Document 009113.1.1 - Addendum No. 1

DeKalb County, Illinois
Courthouse Addition
Bid Package 1

PSA-Dewberry No.: 50038973

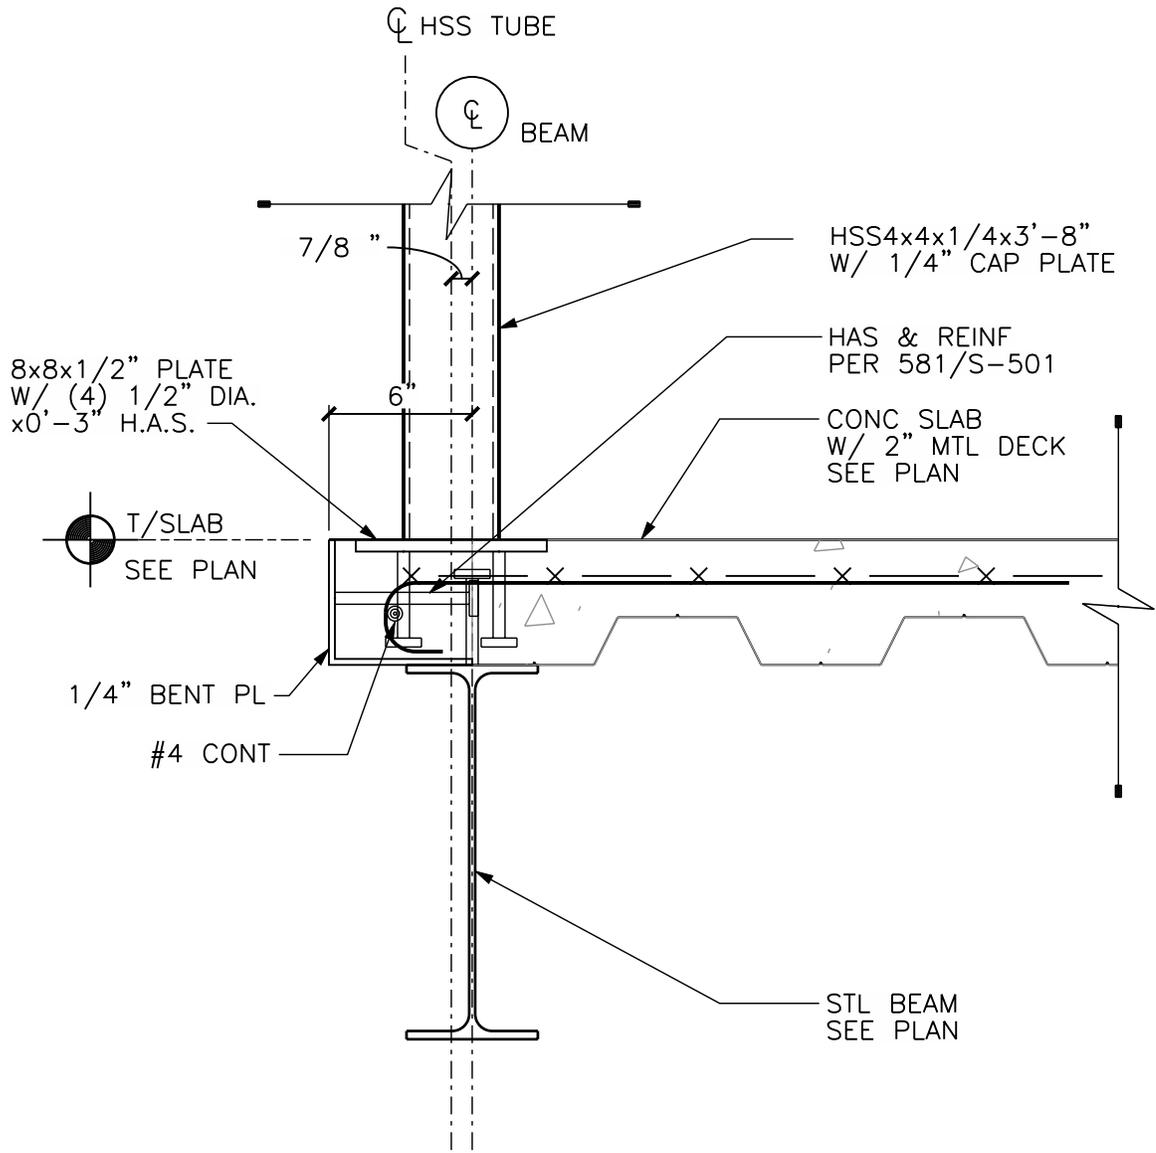
1. REVISE edge of deck in detail 3 as shown in the attached sketch SSK-06.
2. REVISE headed anchor stud size and HSS tube location in detail 5 as shown in the attached sketch SSK-07.
3. REVISE edge of deck in detail 6 as shown in the attached sketch SSK-08.
4. ADD 3/16” field weld of beam to bearing plate in detail 7.
5. ADD slab reinforcing in detail 10 as shown in the attached sketch SSK-09.

PSA Dewberry PSA DEWBERRY 25 S. GROVE AVE., SUITE 500 ELGIN, IL 60120 (847) 695 5840 (847) 742 4571 Fax	REVISE TOP OF WALL	Date: 01-04-11	Issued As: ADD. #1 -BP#1	Sketch No.: SSK-10
	Project: DEKALB COUNTY COURTHOUSE ADDITION	Scale: AS INDICATED	Project No.: 50038973	Drawing Reference No.: 2/S-311

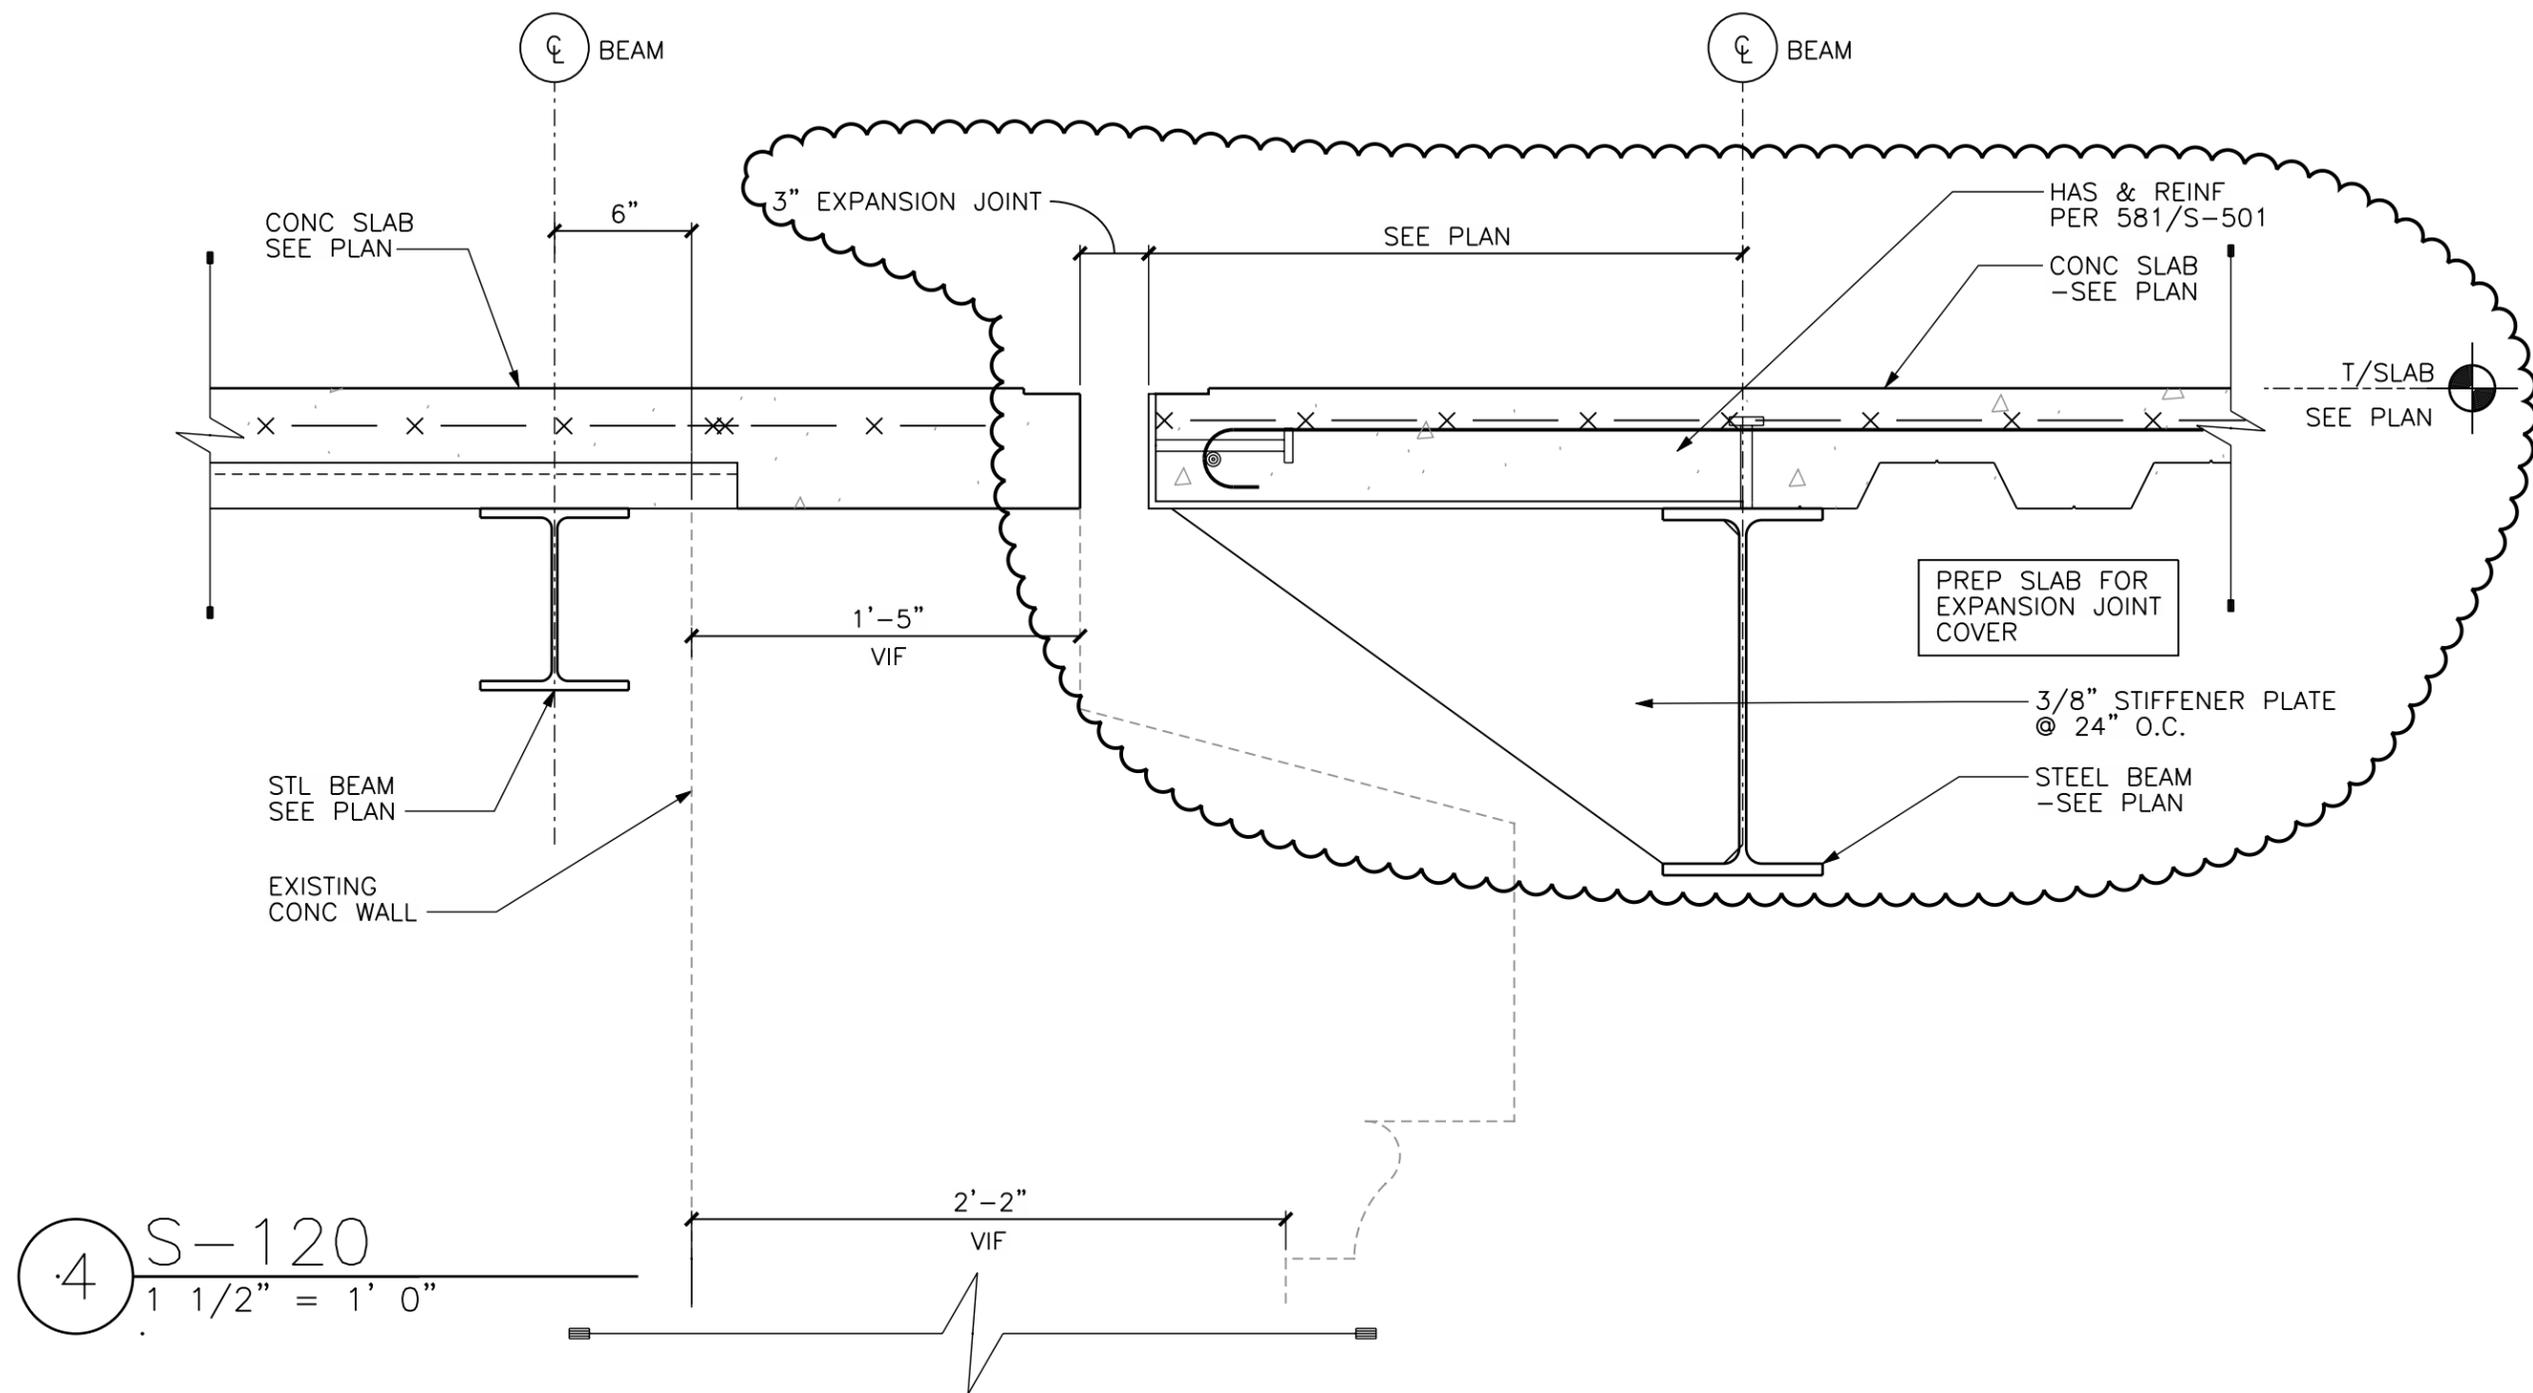
1. REVISE top of wall deck framing in detail 2 as shown in the attached sketch SSK-10.
2. REVISE edge of deck and expansion joint in detail 4 as shown in the attached sketch SSK-11.
3. ADD 3/16” field weld of channel to beam at each end in detail 7.

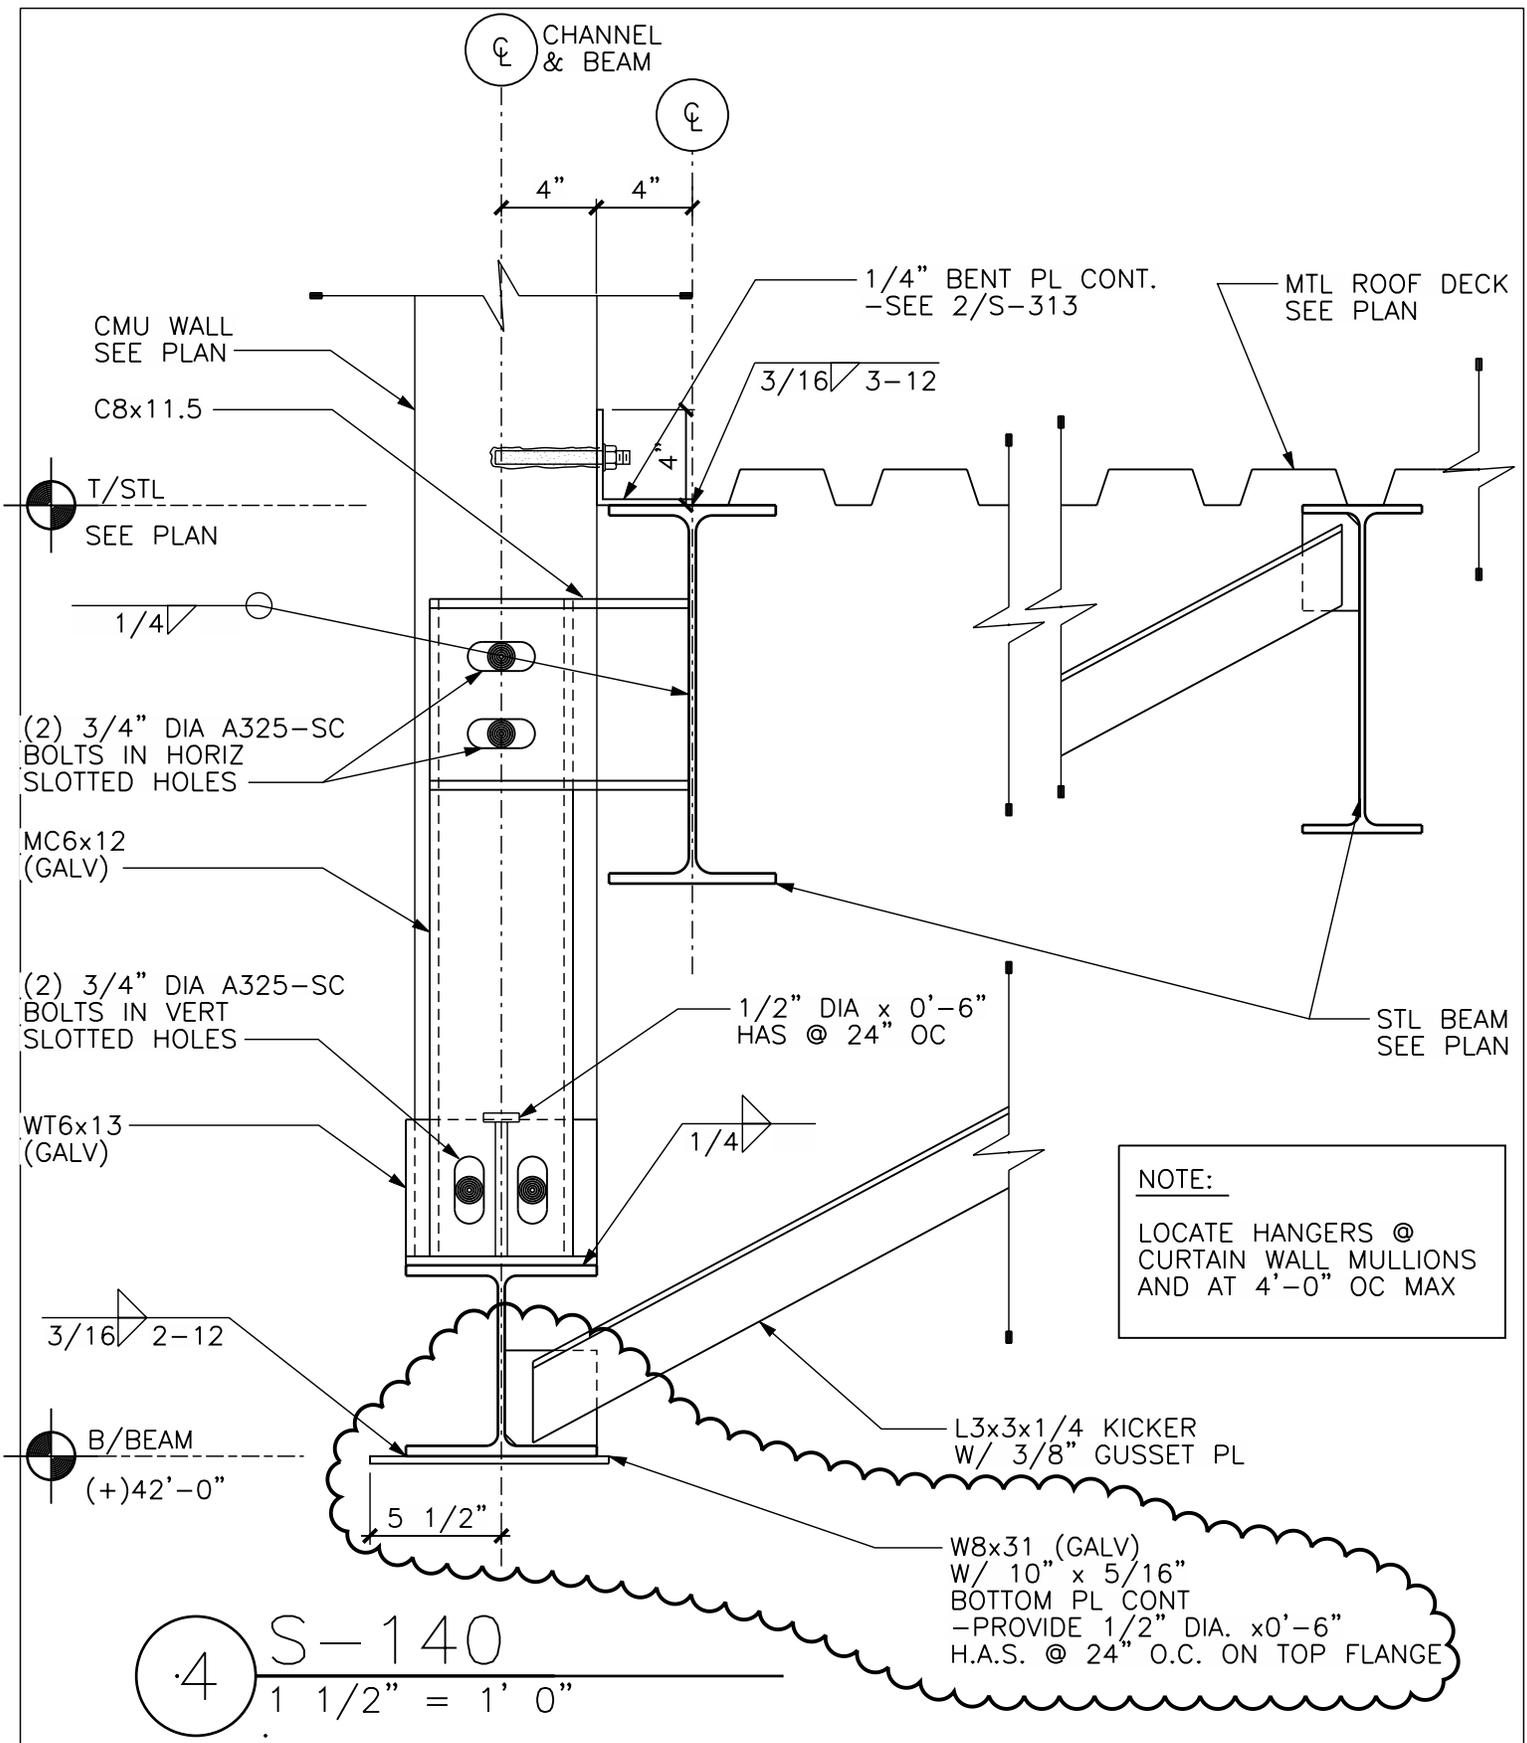
1. REVISE lintel configuration in detail 3 as shown in the attached sketch SSK-12.
2. REVISE lintel configuration in detail 4 as shown in the attached sketch SSK-13.
3. REVISE edge of deck and welding requirements in detail 7 & 8 as shown in the attached sketch SSK-14.

NOTE:
 LOCATE HANGERS @
 CURTAIN WALL MULLIONS
 AND AT 4'-0" OC MAX

Sketch No.: SSK-15

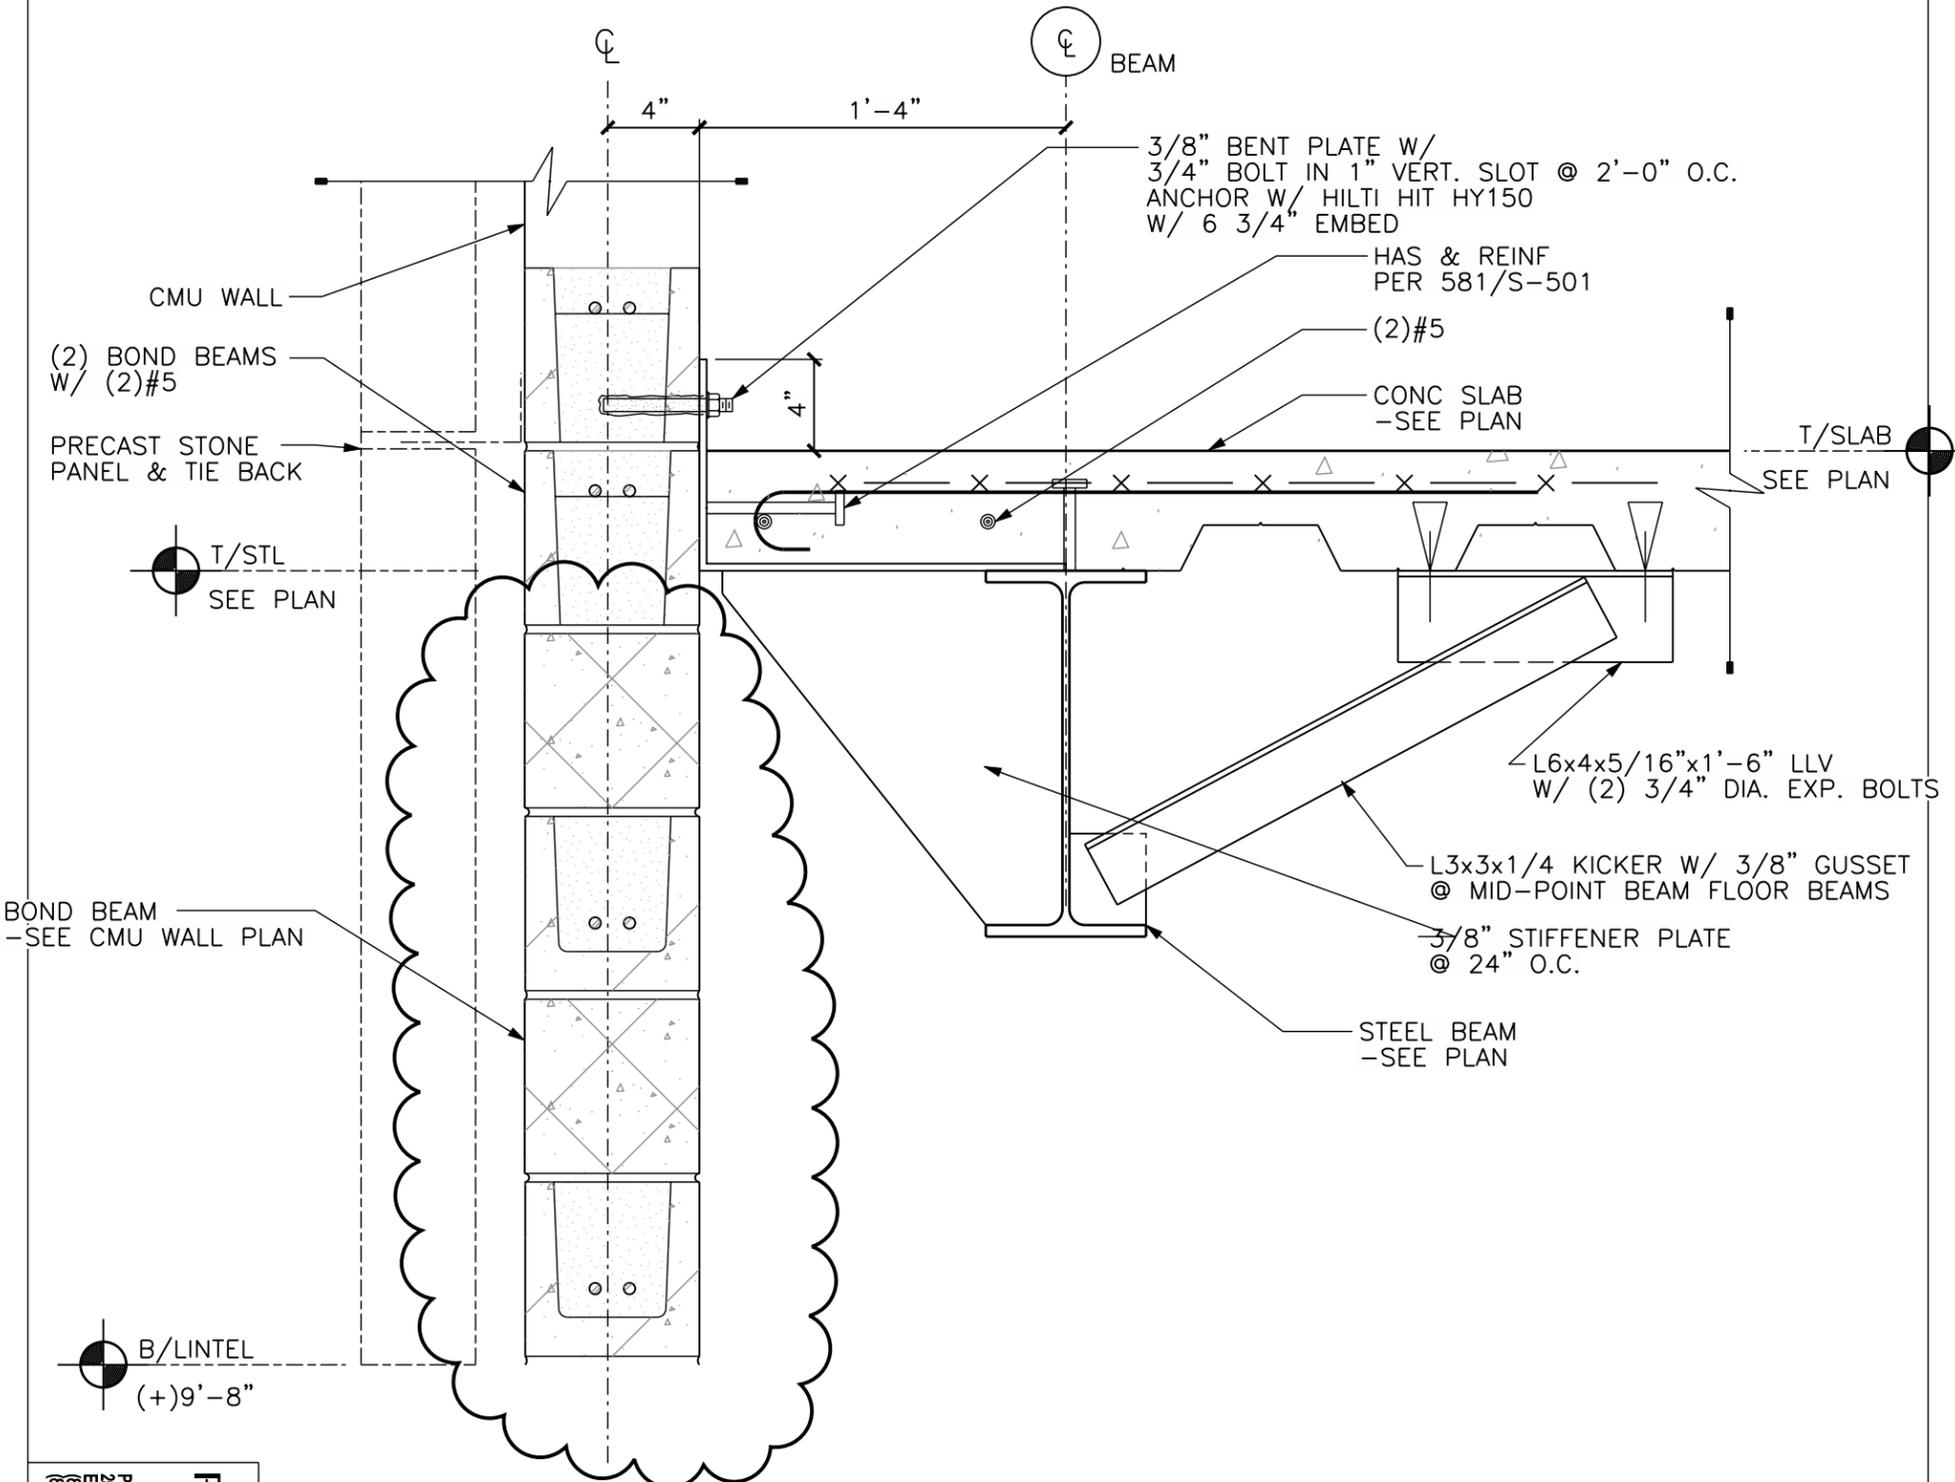
1. REVISE lintel configuration in detail 1 as shown in the attached sketch SSK-15.
2. REVISE concrete curb configuration in detail 5 as shown in the attached sketch SSK-16.
3. REVISE lintel configuration in detail 7 as shown in the attached sketch SSK-17.
4. REVISE general note for details 2, 5 and 6 to read as follows: “PROVIDE
